# METROPOLITAN GOVERNMENT OF NASHVILLE AND DAVIDSON COUNTY

## STAFF RECOMMENDATION 1624 16<sup>th</sup> Avenue South June 19, 2013

**Application:** Partial demolition; New construction—addition  
**District:** South Music Row Neighborhood Conservation Zoning Overlay  
**Council District:** 19  
**Map and Parcel Number:** 10408035800  
**Applicant:** James Lowen  
**Project Lead:** Melissa Baldock, melissa.baldock@nashville.gov

<p><b>Description of Project:</b> Application is to demolish an existing addition, construct a new rear addition to an apartment structure and make alterations to the historic building.</p> <p><b>Recommendation Summary:</b> Staff recommends approval with the following conditions:</p> <ol style="list-style-type: none"><li>1. The applicant submit more information about the installation of the lap siding on the historic structure and the stucco have a smooth finish;</li><li>2. Staff review the final choices for the roof color and the window and door selections; and</li><li>3. The utilities be placed at the rear of the structure, or on a side façade, beyond the midpoint of the historic structure, if a new location is planned.</li></ol> <p>With these conditions

Figures 2 & 3. The rear addition seen here will be demolished, as will the majority of the structure's back wall and back roof slope.

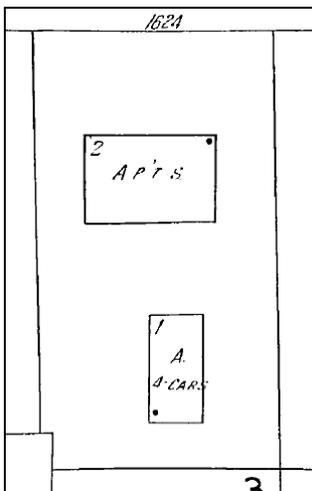
Partial demolition: The applicant proposed to demolish an existing one-story rear addition at 1624 16<sup>th</sup> Avenue South (Figures 2 & 3 on next page). This one-story portion of the structure does not appear on the 1951 Sanborn map, and is therefore not original to the structure (Figure 4 on next page). Staff finds that its removal will not negatively

affect the historic integrity of the structure or the district as a whole. The construction of the new addition necessitates the removal of much of the back wall and back roof slope of the historic building. All but two feet (2') beyond the corner of the historic structure and the edge of the roof on both sides will be removed for the construction of the proposed addition. Staff finds this to meet the design guidelines because the rear façade is not visible from the street and does not have much architectural interest or integrity. By retaining the two back corners of the building, the original form of the structure can be deciphered and restored should the proposed addition ever be removed in the future. Staff finds that the removal of the existing addition and the majority of the back wall and roof slope of the structure meets Section III.B.2.b. of the design guidelines.

**A1.0**

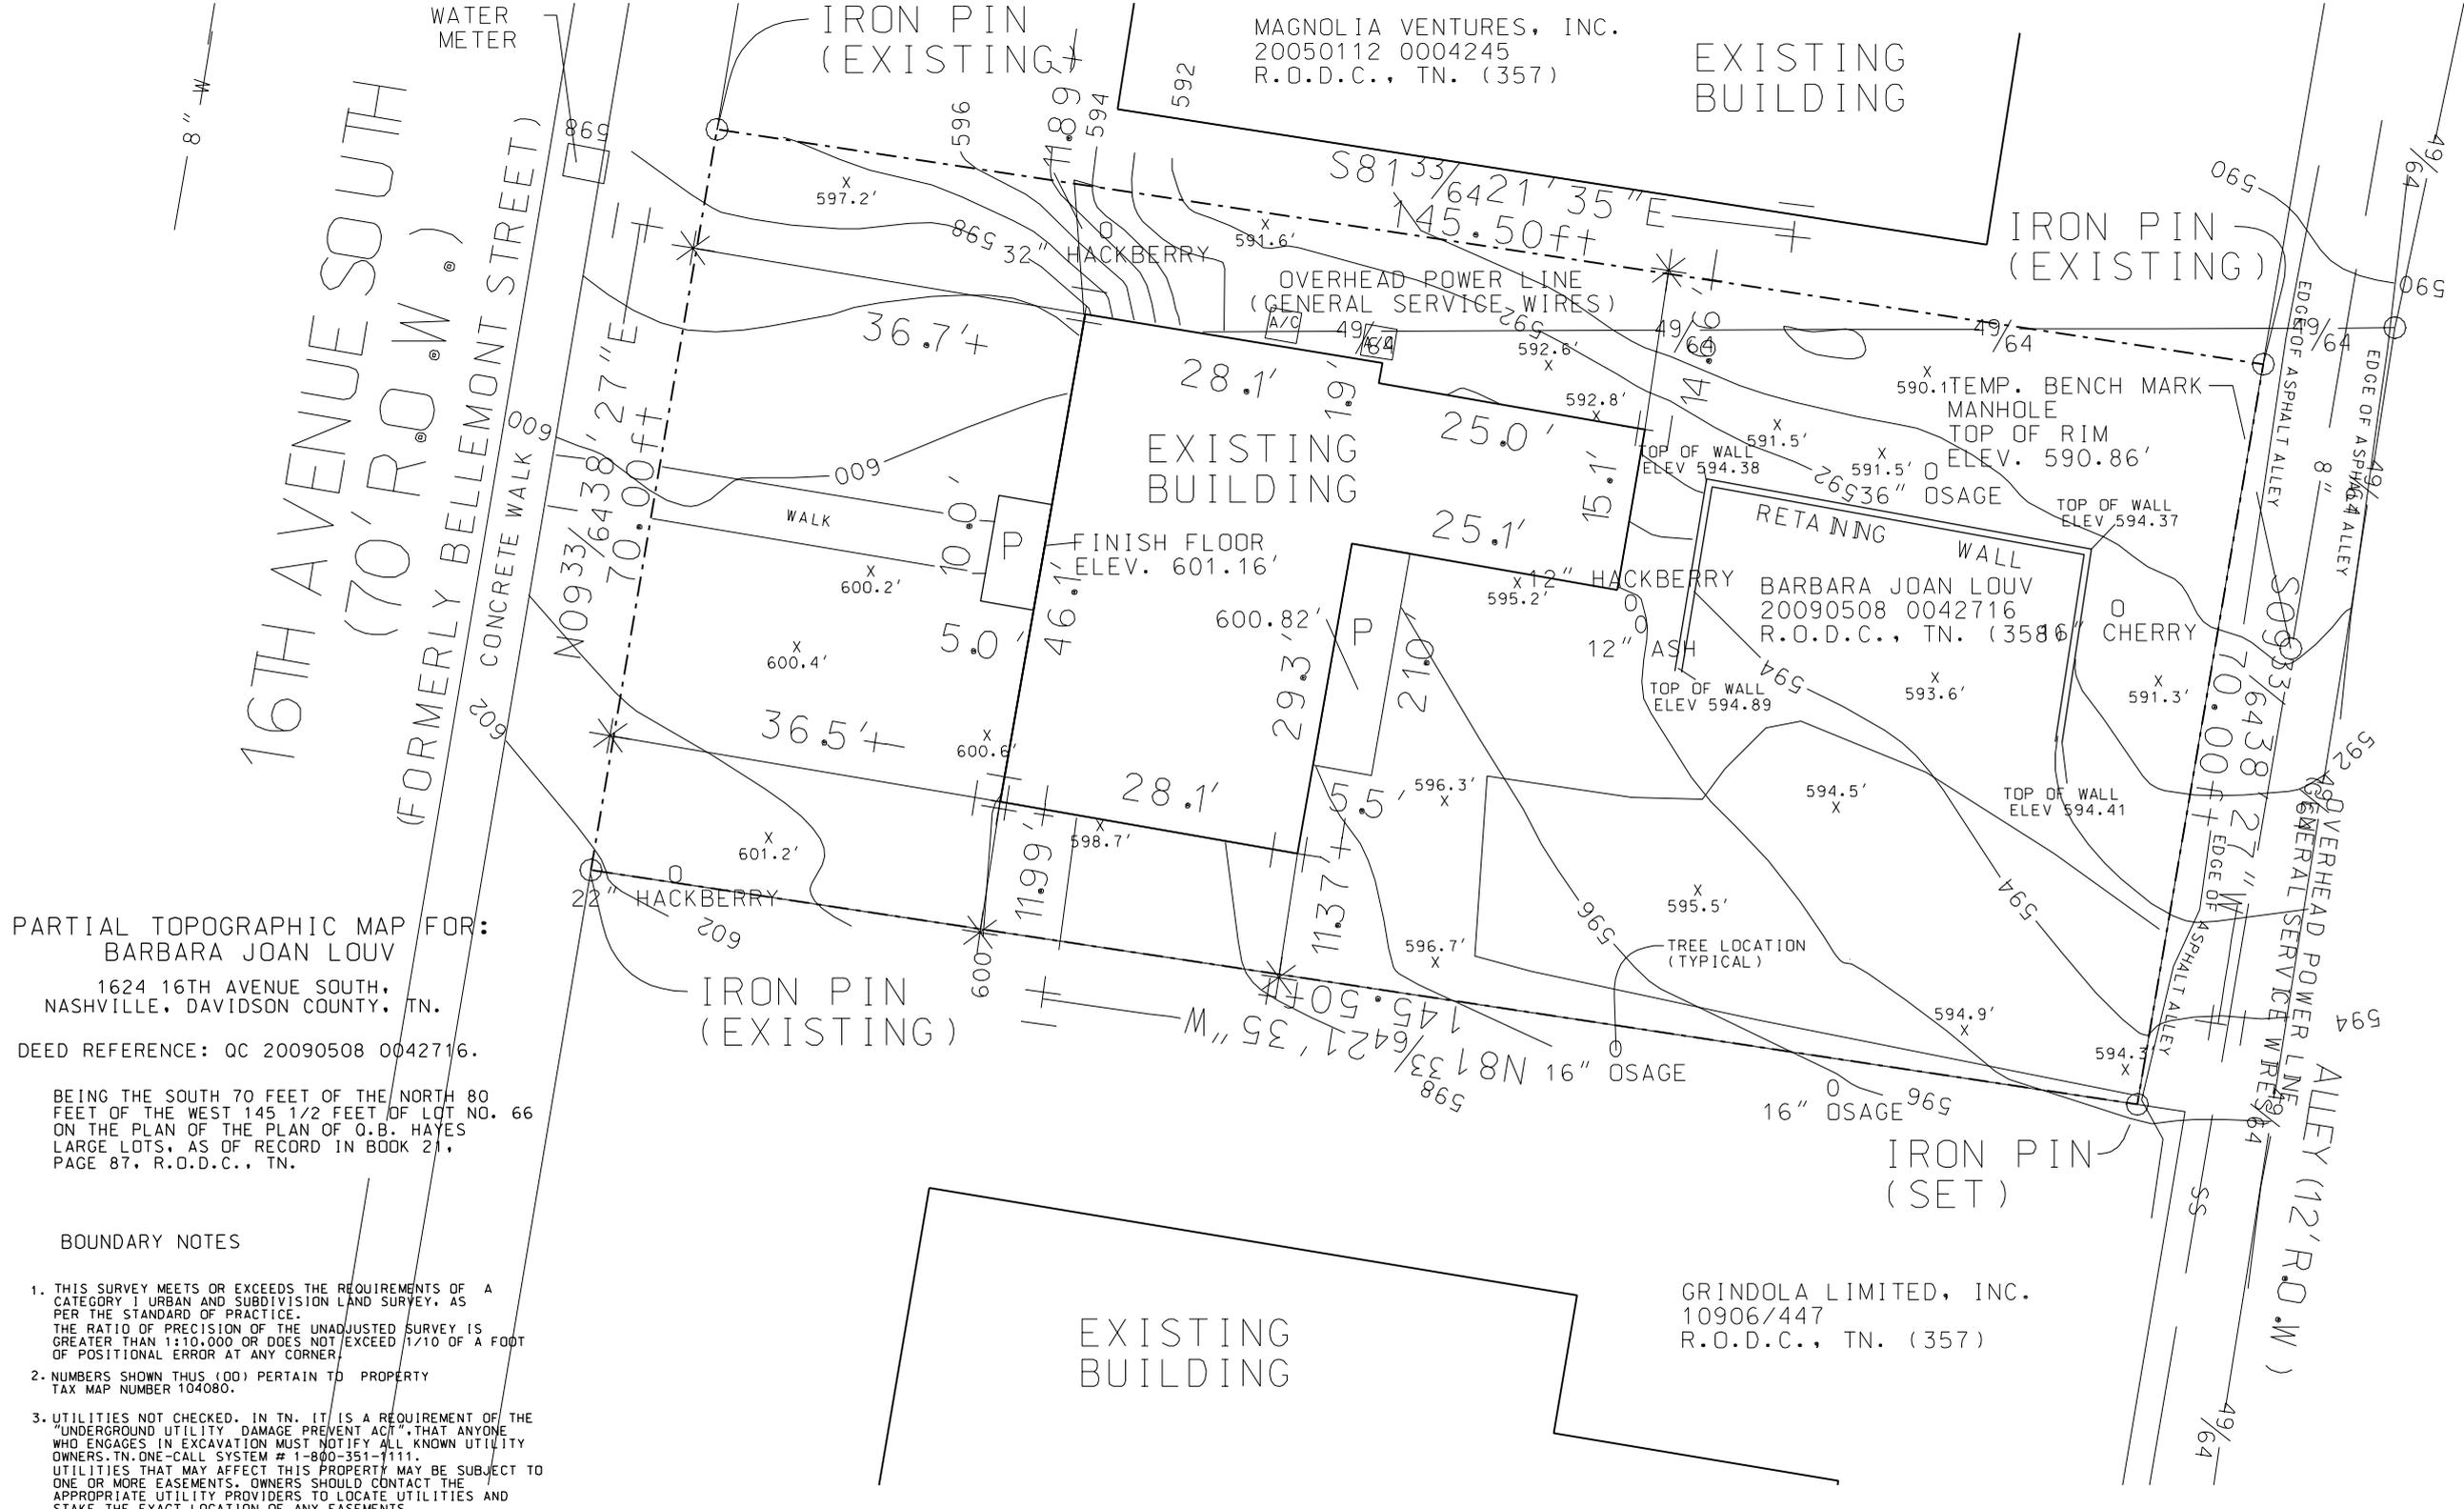
**Location, Setback:** The proposed addition is located entirely behind the historic structure and meets all base zoning requirements for setbacks. At the back of the structure, the addition steps in two-feet (2') from both sidewalls, which is appropriate for a two-story addition. After a depth of fourteen feet, one and one-half inch (14' 1½"), the addition steps back out to line up with the sidewalls of the historic structure. Staff finds that the

addition's location and setbacks meet Sections II.B.1c. and II.B.2. of the design guidelines.

Utilities: The location of the utilities was not indicated on the site plan. Staff asks that they be located at the rear of the structure or on a side façade, beyond the midpoint of the historic structure, if relocation of the existing system is needed.

4. The applicant submit more information about the installation of the lap siding on the historic structure and the stucco have a smooth finish;
5. Staff review the final choices for the roof color and the window and door selections; and
6. The utilities be placed at the rear of the structure, or on a side façade, beyond the midpoint of the historic structure, if a new location is planned.
